The Commission has issued the enclosed Amendment No. 113 to Facility Operating License No. DPR-59 for the James A. FitzPatrick Nuclear Power Plant. The amendment consists of changes to the Technical Specifications in response to your application transmitted by letter dated March 16, 1987.

JAMES A. FITZPATRICK NUCLEAR POWER PLANT

AMENDMENT TO FACILITY OPERATING LICENSE

Amendment No. 113
License No. DPR-59

**FIGURE 3.6-1
REACTOR VESSEL PRESSURE - TEMPERATURE LIMITS**

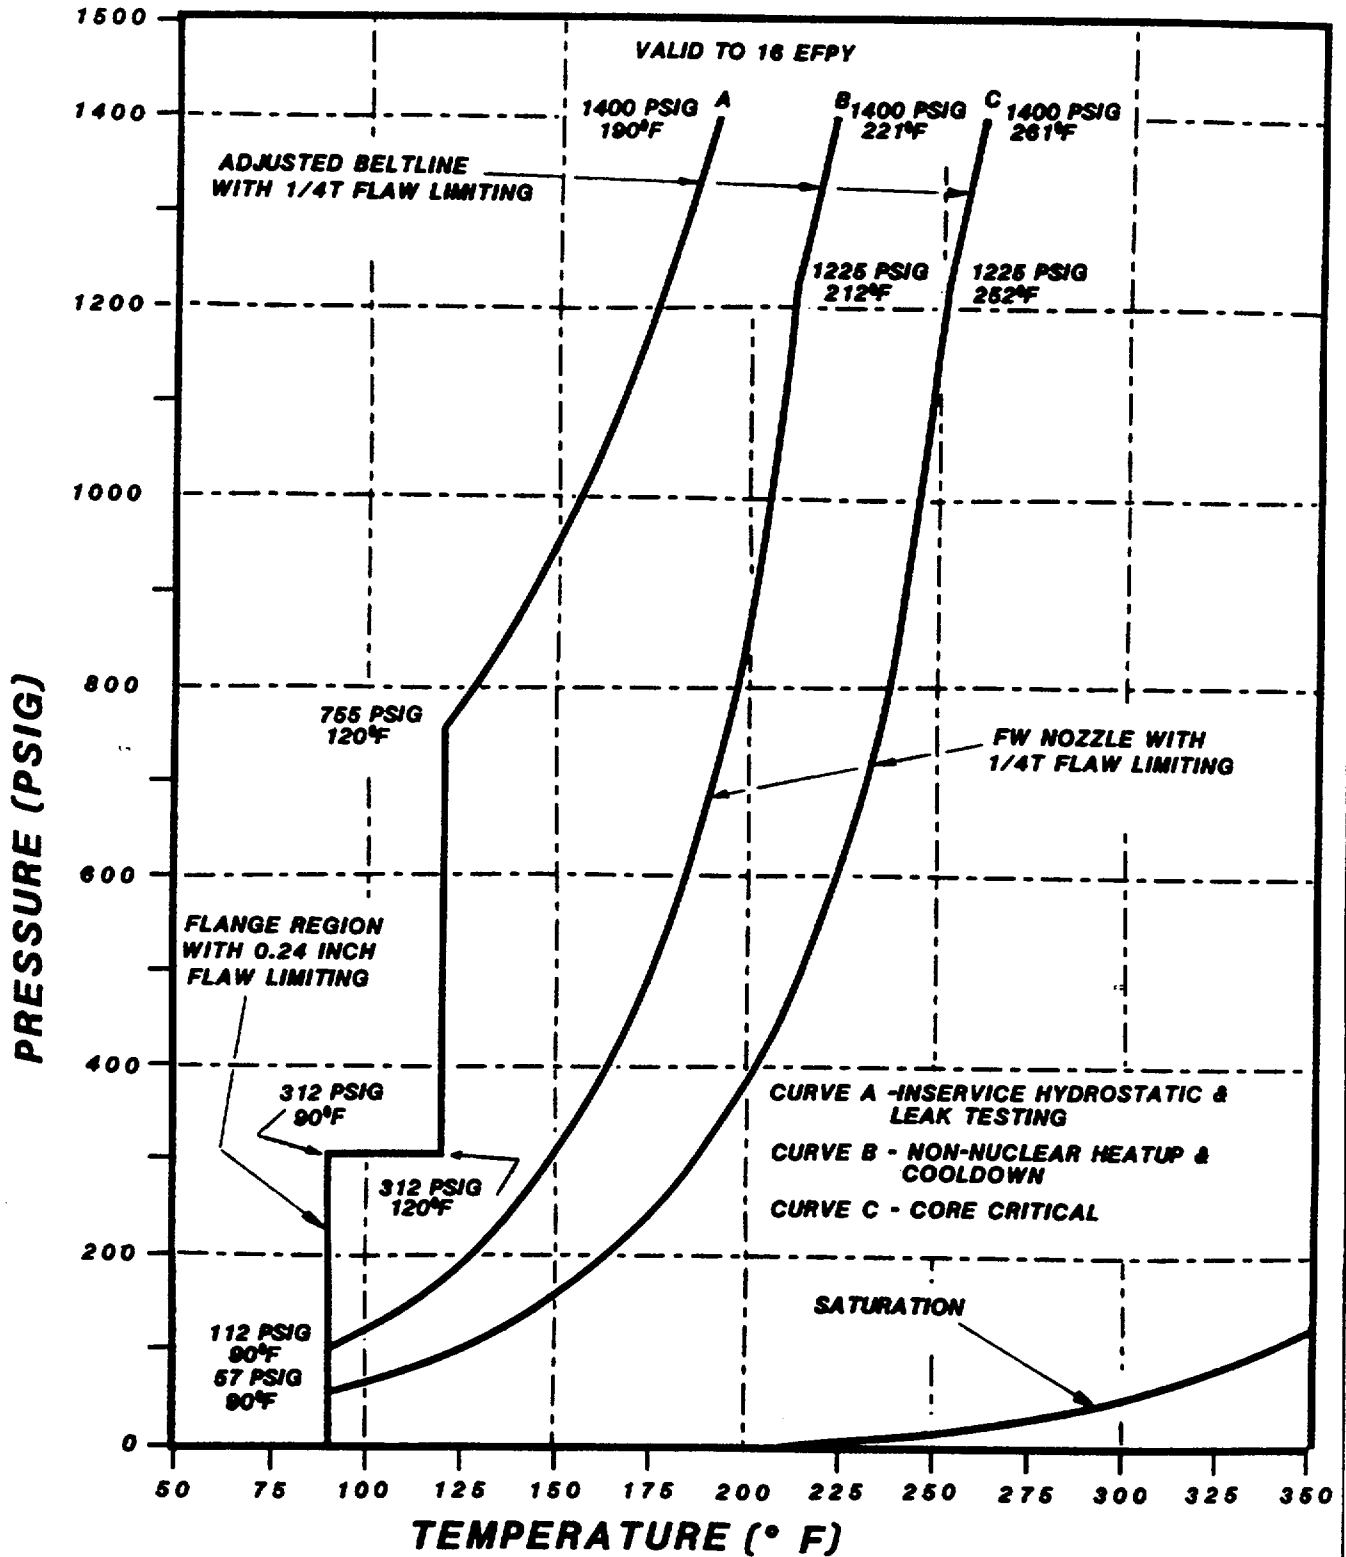
The amendment would change the Technical Specifications to include revised limits that restrict operating pressures and temperatures to assure that brittle fracture of the reactor vessel cannot occur and that vessel integrity is maintained.

The first surveillance capsule containing test specimens was withdrawn in April, 1985 after 6 EFPY. The test specimens removed were tested according to ASTM E 185-82 and the results are in GE report MDE-49-0386. The curves of Figure 3.6-1, A through C, reflect findings in the report related to copper-phosphorus content of the reactor vessel shell beltline, flux wire testing fluence distribution analysis, and Charpy V-Notch specimen testing. The next surveillance capsule will be removed after 15 EFPYs of operation and the results of the examination used as a basis for revision of Figure 3.6-1 curves A, B and C for operation of the plant after 16 EFPYs.

Figure 3.6-1 curve A establishes the minimum temperature for hydrostatic and leak testing required by the ASME Boiler and Pressure Vessel Code, Section XI. Test pressures for in-service hydrostatic and leak testing are a function of the testing temperature and the component material. Accordingly, the maximum hydrostatic test pressure will be 1.1 times the operating pressure or about 1105 psig.

Figure 3.6-1, curve B, provides limitations for plant heatup and cooldown when the reactor is not critical or during low power physics tests. The thermal limitation is based on maximum heatup and cooldown rates of 100°F/hr in any one-hour period.

Figure 3.6-1, curve C, establishes operating limits when core is critical. These limits include a margin of 40°F as required by 10 CFR 50 Appendix G.

By letter dated March 16, 1987, the Power Authority of the State of New York proposed to revise the pressure-temperature limits in the James A. FitzPatrick Nuclear Power Plant Technical Specifications (TS), Section 3.6. The proposed pressure-temperature limits were developed from a General Electric (GE) report that the licensee submitted on April 12, 1985. The report is entitled, "James A. FitzPatrick Nuclear Power Plant Reactor Pressure Vessel Surveillance Materials Testing and Fracture Toughness Analyses," MDE-49-0386. The pressure-temperature limits are a set of curves that set minimum pressure and temperature for three reactor operating conditions: system hydrostatic and leakage tests, heatup or cooldown, and core critical operation.

At higher temperature and pressure ranges, the pressure-temperature limits are based on the material that has the largest shift between the adjusted RT_{NDT} and the initial RT_{NDT} . The plate was found to be the limiting material for operation up to 16 EFPY and has an adjusted RT_{NDT} of 86°F. Beyond 16 EFPY, the weld will be the limiting material due to the higher irradiation shift. The staff has determined that the three proposed pressure-temperature curves satisfy the safety margins as required by Appendix G of 10 CFR 50.

During in-service hydrostatic or leak testing the Reactor Coolant System pressure and temperature shall be on or to the right of curve A shown in Figure 3.6-1 and the maximum temperature change during any one hour period shall be:

During heatup by non-nuclear means (mechanical), cooldown following nuclear shutdown and low power physics tests the Reactor Coolant System pressure and temperature shall be on or to the right of the curve B shown in Figure 3.6-1 and the maximum temperature change during any one hour shall be $\leq 100^{\circ}\text{F}$.

During all modes of operation with a critical core (except for low power physics tests) the reactor Coolant System pressure and temperature shall be at or to the right of the curve C shown in Figure 3.6-1 and the maximum temperature change during any one hour shall be $\leq 100^{\circ}\text{F}$.

In summary, the staff has determined that the licensee has adequate surveillance capsules for the reactor beltline materials inside of the reactor vessel and has an acceptable fracture toughness testing program for the irradiated materials. The licensee has appropriately applied Appendix G of 10 CFR 50 and Regulatory Guide 1.99, Revision 1, to develop the pressure-temperature limits. These limits are valid up to 16 EFPY and may be incorporated into the FitzPatrick TS.
